ROADSTER 2013 Special Repair Needed at PDI - 40182

A very limited quantity of vehicles may have been produced with incorrectly routed electrical wires and brake lines.

Re: Model Year 2013 Can-Am™ Spyder - Special Repair Needed at PDI

Inspection of the LH side Brake Hose

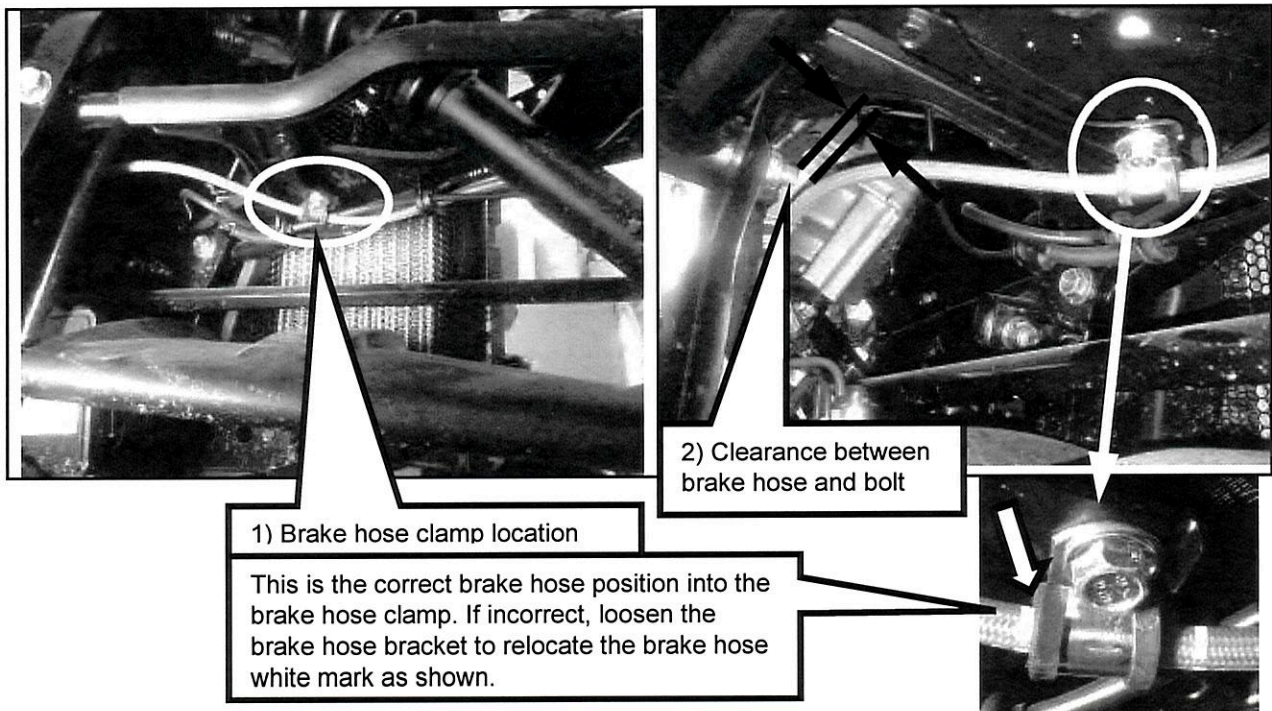
- 1) Ensure the brake hose white mark (the one toward the center of the vehicle) is in contact with the brake hose anchoring bracket rubber piece.
- 2) Ensure there is clearance between the bolt and the brake hose to avoid any contact.

Inspect Wires Routing

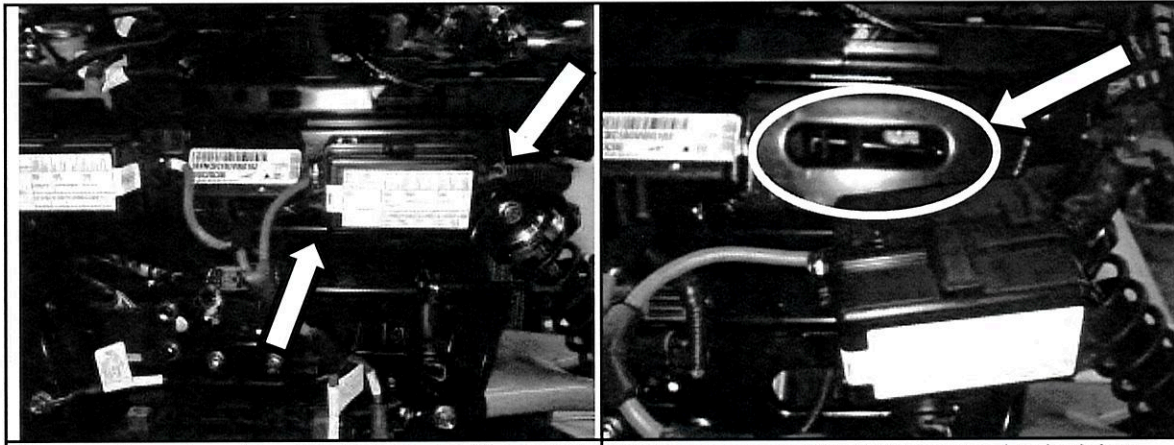
Remove fuses box from the front frame (2 screws) | This is the access window you need to look into.

You may see up to 3 wires between the ECM lower anchoring point and the center of the vehicle.

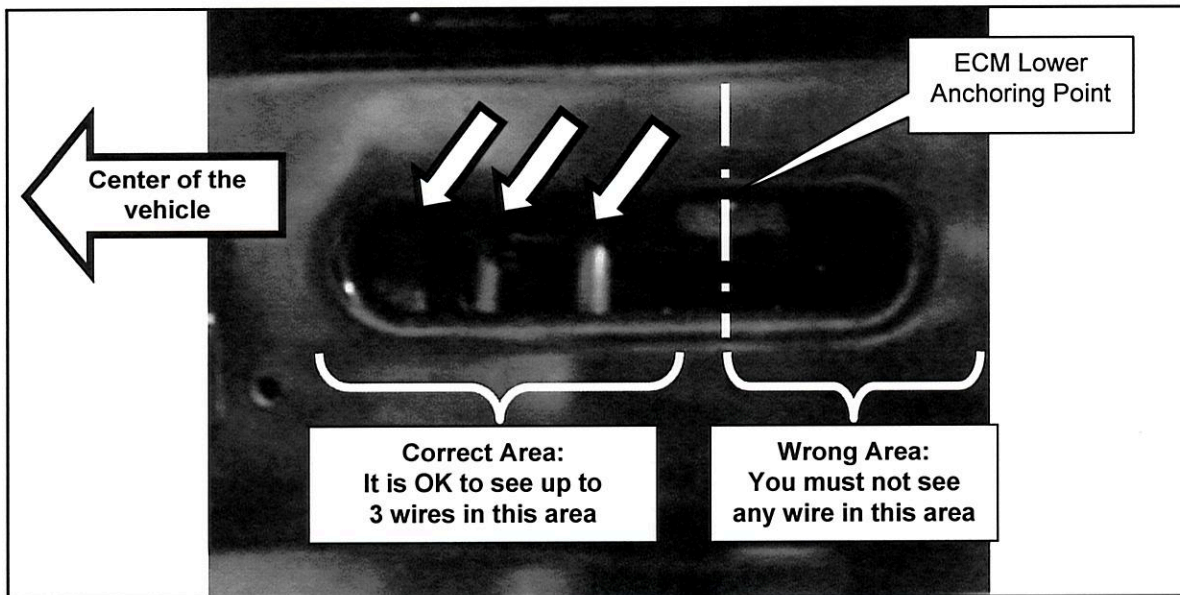
- Red positive cable with corrugated over it
- Regulator/rectifier wires (2) protected by harness tape
- Large black ground cable

Correct Routing	Wrong Routing
<ul style="list-style-type: none"> • Up to 3 wires are visible in the correct area • Each visible wire can be moved slightly with fingers (side-to-side) 	<ul style="list-style-type: none"> • One or more wire is visible in the Wrong Area • One or more wire can not be moved slightly from side-to-side with fingers (must not feel pinched)
<p>No correction needed: reassemble fuse box</p>	<p>Solution: Reroute wire(s), or replace damaged/pinched wire(s).</p>

Repair Wire(s) Routing (if needed)

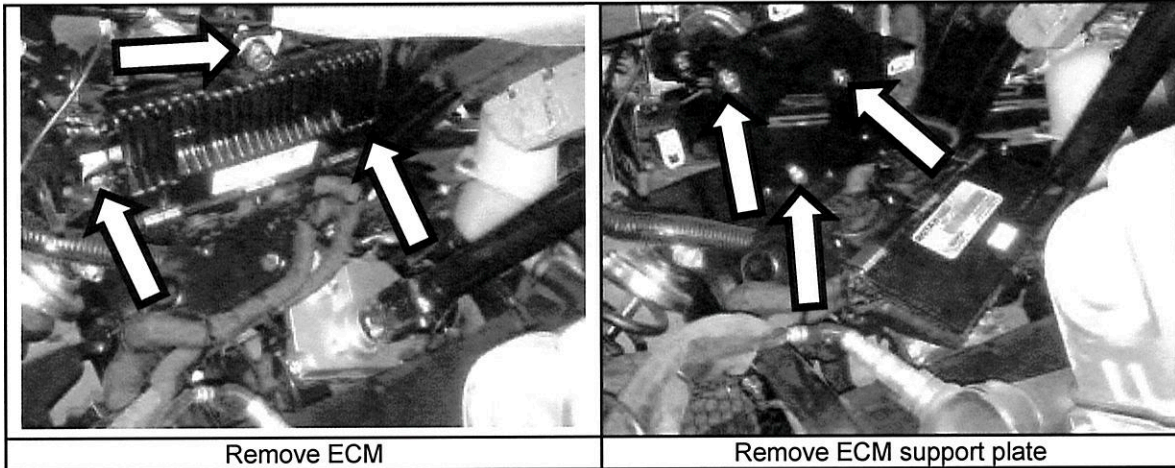
Use the appropriate Shop Manual to reach and remove the air box, and to access the wires area. Until the final Shop Manuals are available through the normal channel, some temporary Shop Manual sections were attached to each VIN on BRP Knowledge Base.

Replace any pinched/damaged wire(s).

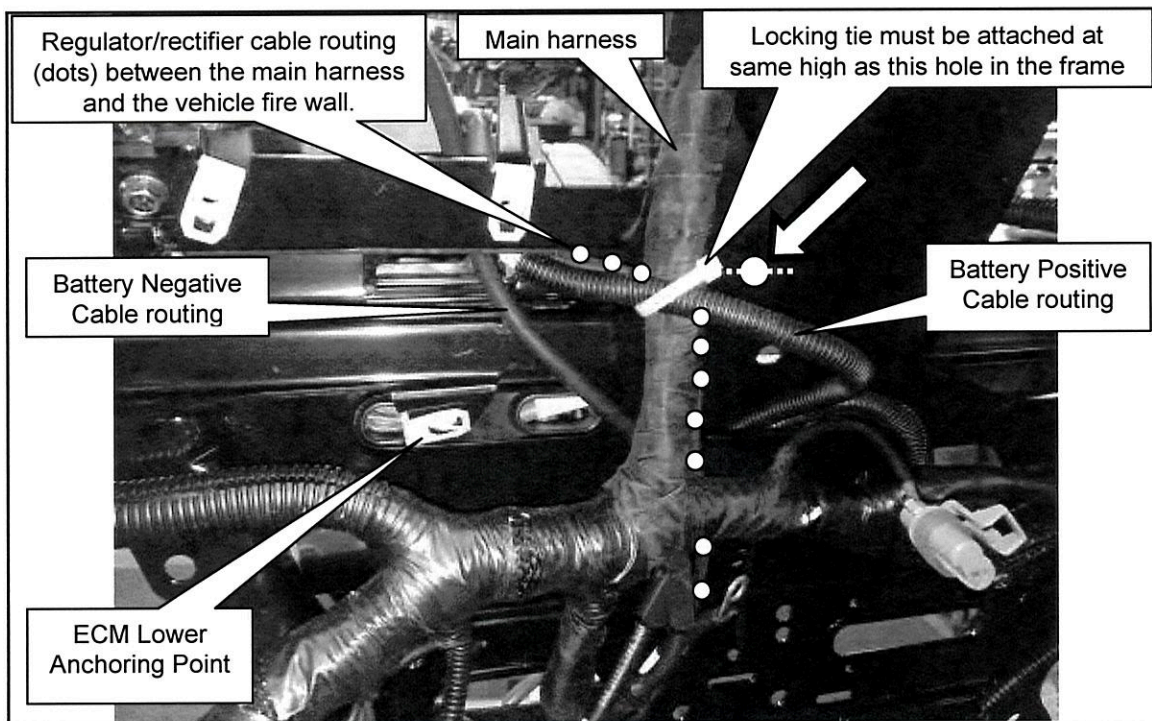
Modify routing as per following pictures for (view is from inside of vehicle, looking towards the front):

- Red positive cable with corrugated over it (P/N 710 002 373)
- Regulator/rectifier wires (2) protected by harness tape (P/N 710 002 716)
- Large black ground cable (P/N 710 002 378)

Make sure that all wires are not pinched and routed away from any sharp edge.
Reassemble all components on vehicle.
